UNITED STATES PATENT AND TRADEMARK OFFICE

Office Action Summary	Application No. 10/574,541	Applicant(s) STROH ET AL.	
	Examiner DEVANG PATEL	Art Unit 4111

DETAILED ACTION

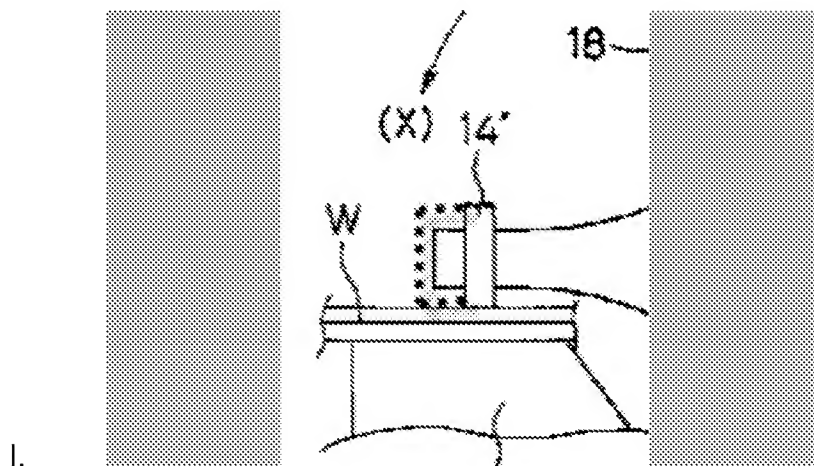
k. As best understood in view of the 112, 2nd rejection above, Tamamoto's reinforcement protrudes from peripheral edge of the front surface. It would have been obvious to have the reinforcement protrude from entire front surface as shown by the dotted line below, and this would include the edge of the working surface as well. Such would have been obvious because there are only a finite number of predictable projection manners (partial surface, multiple reinforcements from partial surfaces, or entire surface), and a person of ordinary skill in the art would have selected any one of above to minimize undesirable deflection.
